September 6, 2018

**Subject: California Department of Fish and Wildlife Review of the Green Diamond Resource Company Draft Forest Habitat Conservation Plan and Draft Environmental Impact Statement**

Figure 2. "Dendritic" post-harvest Riparian Management Zone habitat retention within 0.5 mile (circle) of an NSO site on GDRCo land. Compare with Figure 1 showing the configuration of nesting/roosting habitat in territories with high Habitat Fitness Potential.

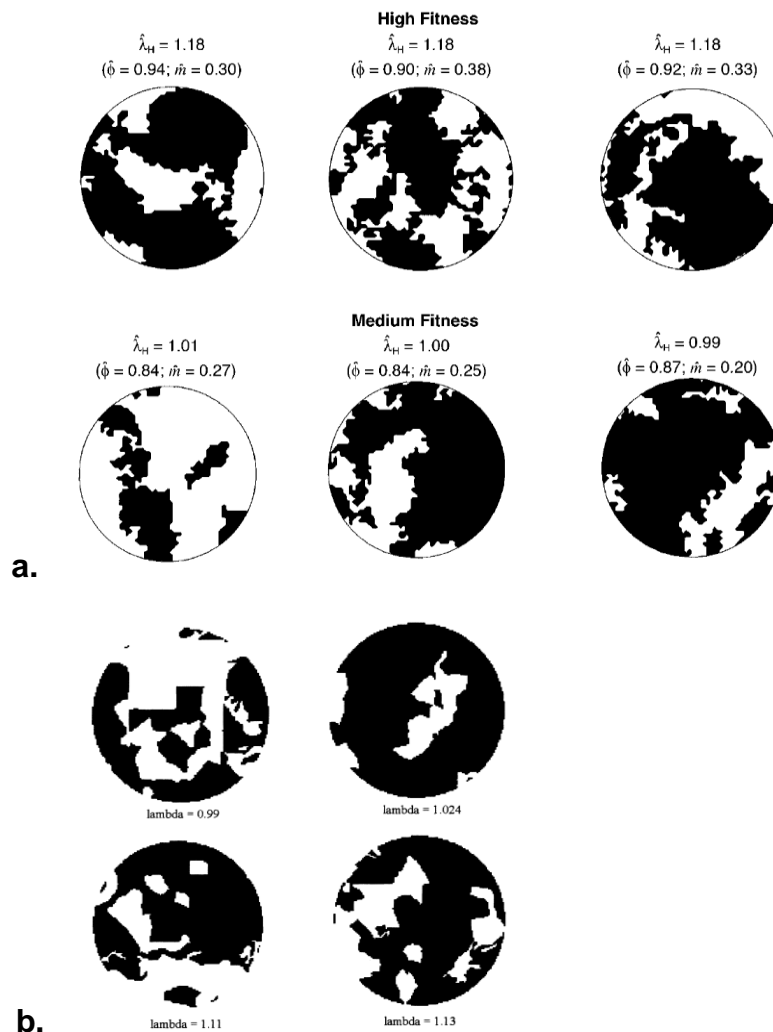
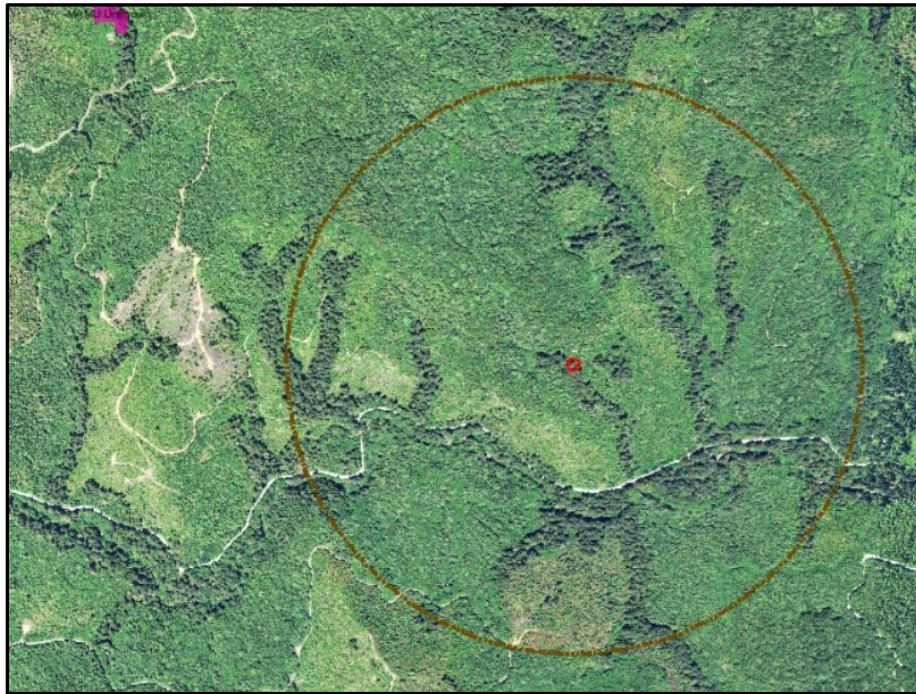
In contrast with the implications of published research on the habitat relationships of NSOs, the FHCP's conservation strategy relies to a large degree on retention of relatively narrow Riparian Management Zones (FHCP Section 5; e.g., see Figure 2) and small geologically unstable areas, which may often provide high amounts of habitat edge but little or no interior nesting/roosting habitat. While patches of nesting/roosting habitat with those shapes potentially support reasonably high occupancy or reproduction on GDRCo land, they may not support high survival (see GDRCo results in Dugger et al. 2016). Like other HFP modeling studies, GDRCo's HFP modeling indicated that survival of NSOs was positively influenced by nesting habitat. However, the nesting habitat variable in the modeling (*nest\_HSI*) was averaged within a 279-acre buffer around each NSO site, and the actual sizes, shapes, or clustering of nesting habitat patches in territories with high survival or fitness were not reported. Given that NSO populations are most sensitive to changes in adult survival (Noon and Biles 1990, Lande 1991), the FHCP should include more consideration of the habitat conditions associated with high survival and fitness, rather than primarily focusing on conditions associated with high occupancy and fecundity. CDFW recommends the FEIS evaluate the HFP modeling's implications for territory-scale conservation of NSOs in the Plan Area; for example, in regard to the size, shape, and clustering of nesting/roosting habitat patches associated with high survival and fitness. **(Recommendation 3).**

The FHCP's authorized rate of take (3 per 100 NSO sites) is based on GDRCo's estimated rate of take under the 1992 HCP (FHCP Section 6). The FHCP (Section 6.2.2.3) anticipates that the actual rate of take will be lower than under the 1992 HCP because it predicts that NSOs will move from areas desirable for harvesting (e.g., upland areas with residual older trees) to RMZs and geologically unstable areas. Yet, it is also possible that the rate of take could be higher under the FHCP than under the 1992 HCP. For example, GDRCo's HFP and demographic modeling suggest that harvesting the 1992 HCP set-asides under the FHCP will negatively impact the population (summarized above and in CDFW Comment Section 1). The FHCP's conservation strategy for NSOs is largely based on retention in narrow ("dendritic") RMZs and often-small geologically unstable areas (FHCP Section 5; e.g., see Figure 2

- 3) The FEIS should evaluate the HFP modeling’s implications for conservation of NSOs in the Plan Area additional to the importance of habitat edge; for example, in regard to the size, shape, and clustering of nesting/roosting habitat patches associated with high survival and fitness.**

- 4) The FEIS should evaluate the FHCP’s conservation strategy (e.g., “dendritic” habitat retention) and mitigation for take (DCAs, rather than set-asides) in light of GDRCo research showing the importance of set-asides to NSOs in the Plan Area.**

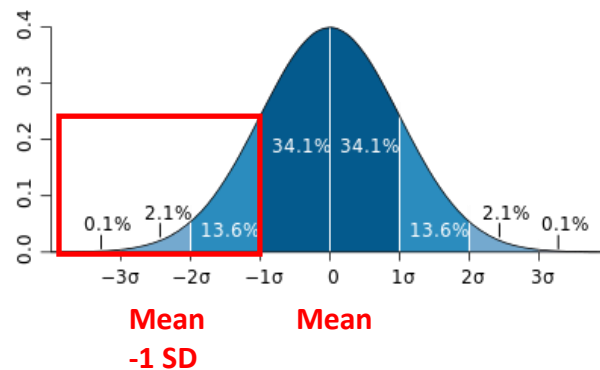
The FHCP and 1992 HCP's habitat thresholds (mean -1SD) represent the lower end of habitat conditions in NSO territories in Folliard's (1993) thesis. If Folliard's (1993) data were normally distributed (i.e., distributed in a bell-shaped curve), the mean -1SD would represent the lowest 16% of his sample, in terms of amounts of habitat (see Figure 3). Although Folliard's (1993) data were likely not perfectly normally distributed, the mean -1SD represents the habitat conditions in the lower portion of his distribution. Folliard (1993) found evidence of territory-scale selection by NSOs for habitat  $\geq 31$  years and  $\geq 46$  years but did not relate amounts of those habitat classes to habitat quality or take. In the absence of such information (i.e., in 1992), it would be more conservative, from the standpoint of avoiding take, to use Folliard's (1993) mean values, rather than the mean -1SD. The mean amount of forest  $\geq 46$  years in Folliard's (1993) sample is 239 acres or 48% of the estimated territory. In their publication of Folliard's (1993) master's research, Folliard et al. (2000, page 83) came to the same conclusion, stating "our data suggested that, to maintain Northern Spotted Owls in managed forests of the redwood zone,  $\geq 50\%$  of the landscape or area surrounding nests should be in forests  $>45$ -yr old."

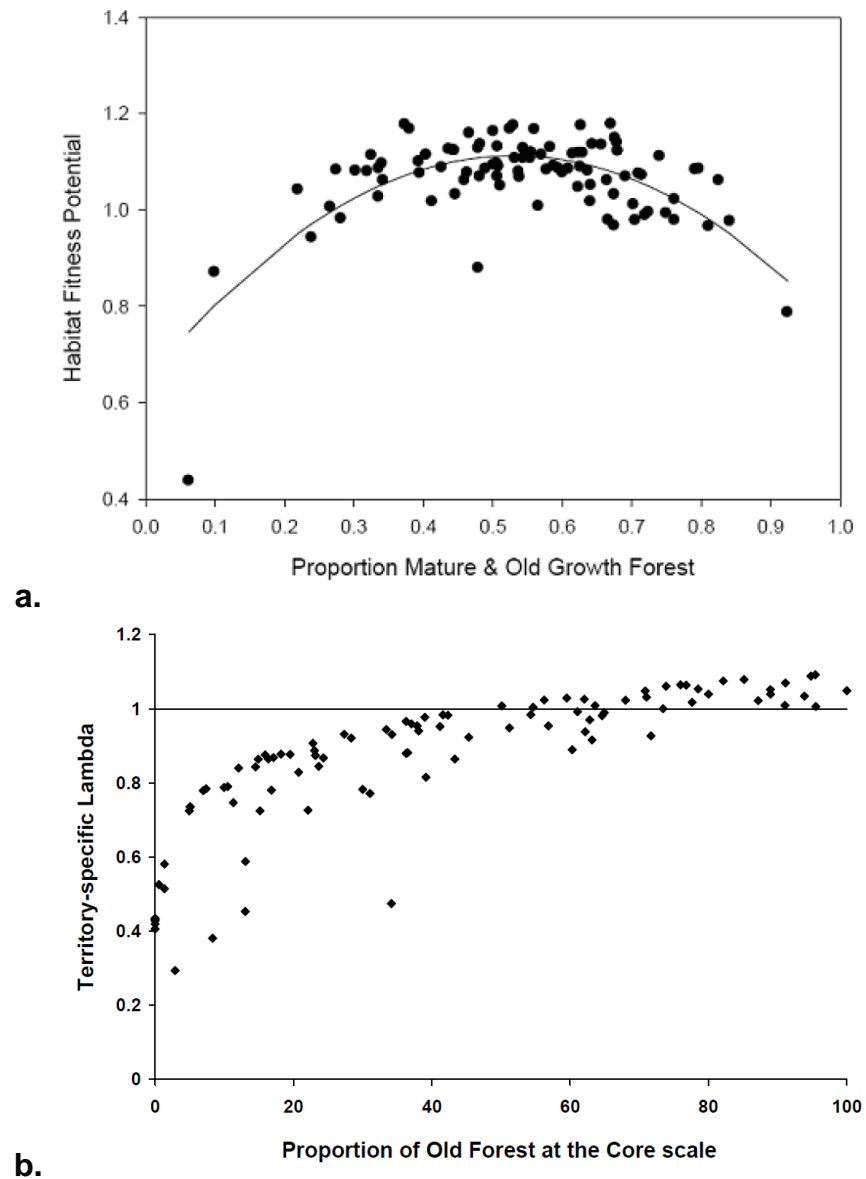
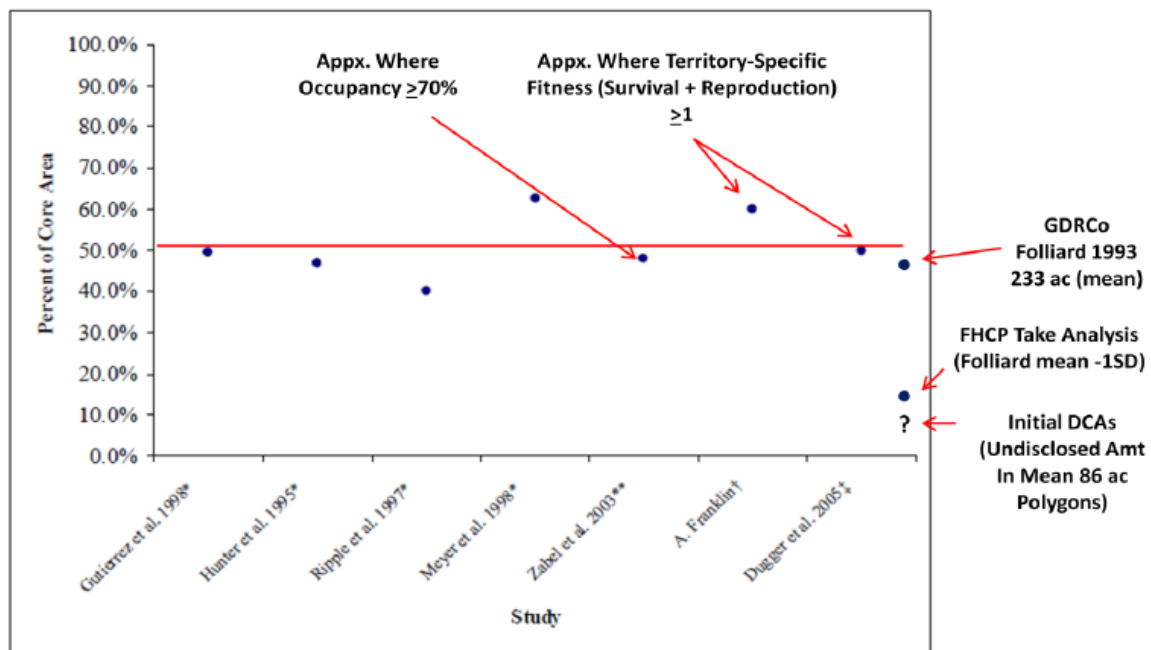
More direct evaluations of habitat quality for NSOs at the territory scale occurred in published Habitat Fitness Potential (HFP) modeling studies in northwestern California (Franklin et al. 2000) and southwestern Oregon (Dugger et al. 2005). Those studies found that NSO territories (413 and 425 acres) supporting high fitness ( $HFP \geq 1$ ) consisted of approximately 40–60% nesting/roosting habitat (reviewed in USFWS 2009; see Figure 4). Across interior northwestern California, NSO sites with high occupancy ( $\geq 70\%$ ) consisted of about 48% nesting/roosting habitat at an estimated territory or core area scale (500 acres) and the highest probability of occupancy occurred with 60–70% of the area in nesting/roosting habitat (Zabel et al. 2003). The central tendency of several studies of habitat use or selection by NSOs in northwestern California and southwestern Oregon provides further support for a take threshold for nesting/roosting habitat of approximately 50% of the estimated territory or core area (Hunter et al. 1995, Ripple et al. 1997, Gutiérrez et al. 1998, Meyer et al. 1998; reviewed in USFWS 2009; see Figure 4). This contrasts with the FHCP's 18% (89 acres) nesting/roosting habitat threshold for analyzing take and selecting DCAs, and the even lower amount of nesting habitat actually retained in DCA no-harvest areas (see Figure 5; also see CDFW Comment Section 5, below). CDFW recommends the FEIS evaluate the appropriateness of 89 acres as a habitat threshold for reporting and analyzing take and for selecting and protecting DCAs. If a take threshold of 89 acres of nesting/roosting habitat is not supported by the best available science, the FHCP should be amended to change that take threshold to one that is supported. **(Recommendations 6 and 7).**

The amount of foraging habitat that should be used as a threshold for avoiding or analyzing take and selecting DCAs is less clear than for nesting/roosting habitat. Estimated NSO core areas (500 acres) across interior northwestern California with high occupancy ( $\geq 70\%$ ) consisted of about 30–40% foraging habitat, in addition to 60–70% nesting/roosting habitat (Zabel et al. 2003). In other words, high occupancy occurred when nearly the entire estimated territory or core area consisted of suitable habitat for NSOs. In contrast, research has suggested that NSOs on GDRCo land select territories containing a variety of forest age classes that are thought to provide a mix of nesting/roosting, foraging, and woodrat habitats (e.g., Thome et al. 1999, Folliard et al. 2000; see FHCP Appendix C). GDRCo's HFP modeling report in FHCP Appendix C does not describe the amount of foraging habitat or total amount of suitable (i.e., foraging + nesting/roosting) found in NSO territories supporting high fitness. However, this information is likely available and could potentially be provided to the Service to assist its evaluation of the FHCP's take thresholds. CDFW recommends the FEIS evaluate the appropriateness of 233 acres of suitable habitat (foraging + some nesting/roosting) as a take threshold in the FHCP. If a take threshold of 233 acres of suitable habitat is not supported by the best available science, the FHCP should be

amended to change that take threshold to one that is supported. (**Recommendations 6 and 7**).

- 7) If one or both of the habitat thresholds identified for DCA retention (89 and 233 acres) is/are not supported by the best available science, the FHCP should be amended to change the threshold(s) to one(s) that is/are supported.

Figure 7. FHCP Map 5-2 showing the locations of Owl Management Units (OMUs) and DCAs. Note the limited number, or lack, of DCAs in many of the OMUs.

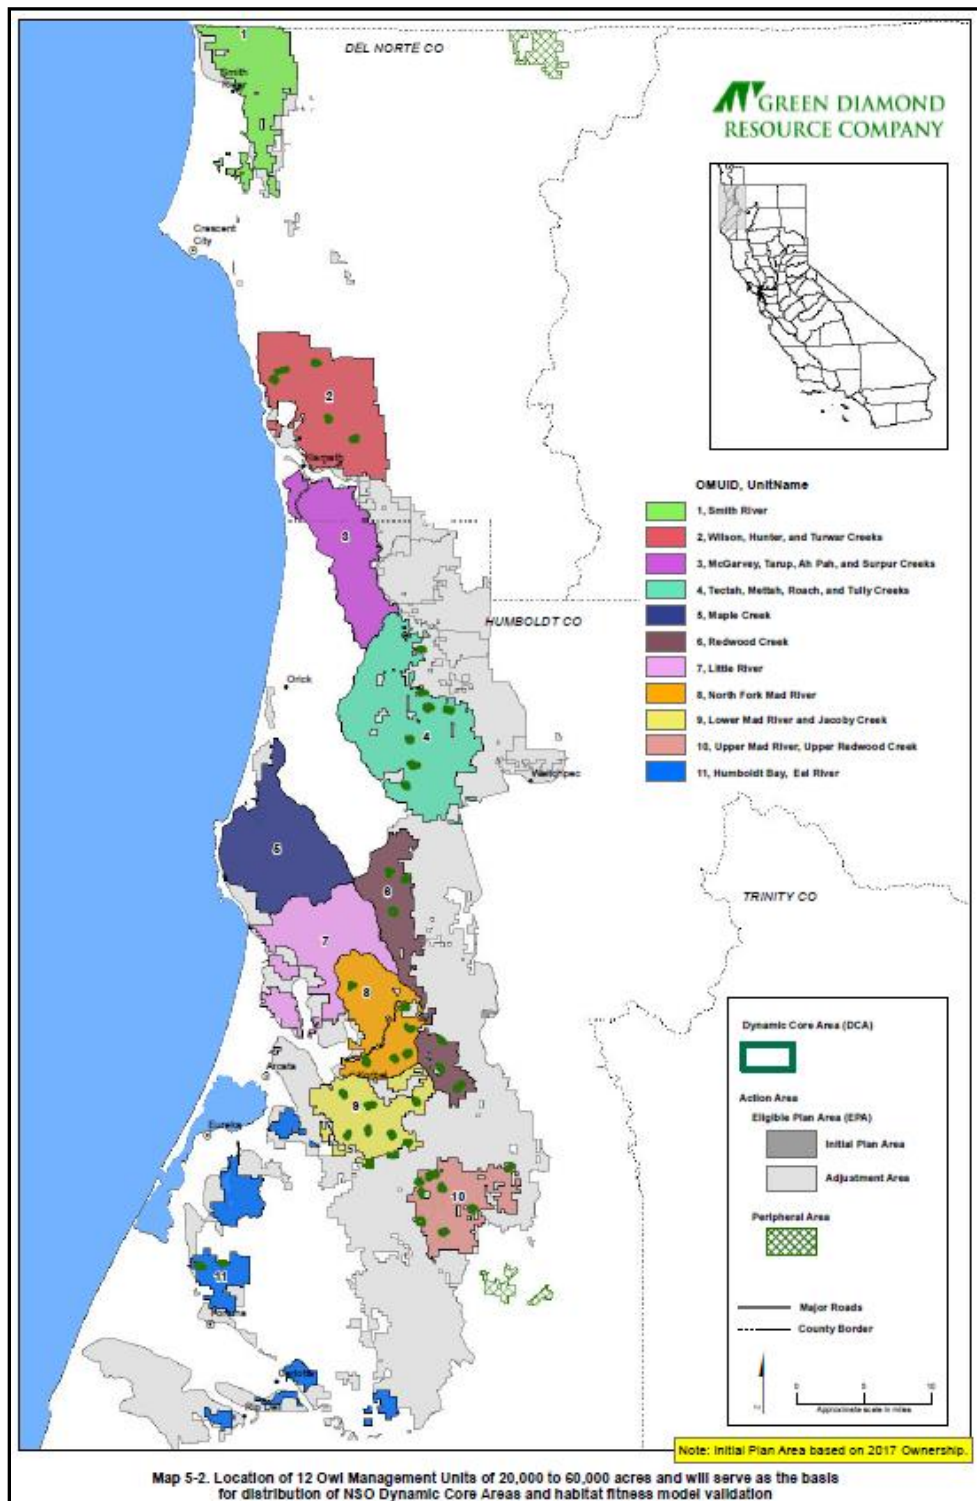
The initial 44 DCAs do not appear to be "distributed throughout the Plan Area" as described in the FHCP (Section 5, multiple subsections, e.g., Section 5.3.1.4). As can be seen in Table 1 and Figure 7 below, many of the 11 Owl Management Units (OMUs) used by the FHCP to select DCAs and monitor the FHCP's NSO conservation strategy (Section 5), have few or no initial DCAs, despite the availability of additional active NSO sites. For example, 4 of the 11 (36%) OMUs have no DCAs. Conversely, the majority (55%) of the DCAs are in just 3 OMUs (see Table 1 and Figure 7). Geographically, northern Del Norte County has no DCAs and the western portion of the Plan Area contains few DCAs (see Figure 7). In terms of the initial DCAs representing the distribution of current active NSO sites, the Smith River OMU has 3 active NSO sites but no DCAs, the Maple Creek OMU has 4 active sites but no DCAs, the Little River OMU has 2 active sites but no DCAs, and the Humboldt Bay, Eel River OMU has 23 active sites but only 2 DCAs (see Table 1). By not distributing DCAs throughout the Plan Area, FHCP Goal One and Objective 1B may not be initially met. CDFW recommends the FHCP be revised so that the initial set of DCAs is better distributed (e.g., in the Plan Area, among OMUs, and in relation to the current distribution of active NSO sites). **(Recommendation 18).**

The FHCP stipulates that new DCAs must replace a DCA in the same OMU, or in the immediately adjacent OMU if the replaced DCA is near an OMU border (FHCP Section 5). Because of this spatial requirement for DCA replacement, it may not be possible for the FHCP to meet Goal One and Objective 1B for many years, if ever, depending on the locations of DCAs being replaced relative to OMU boundaries. CDFW recommends the FHCP be amended to state that replacement DCAs can be selected from adjacent OMUs, regardless of whether the DCA being replaced is near the OMU boundary. **(Recommendation 19).**
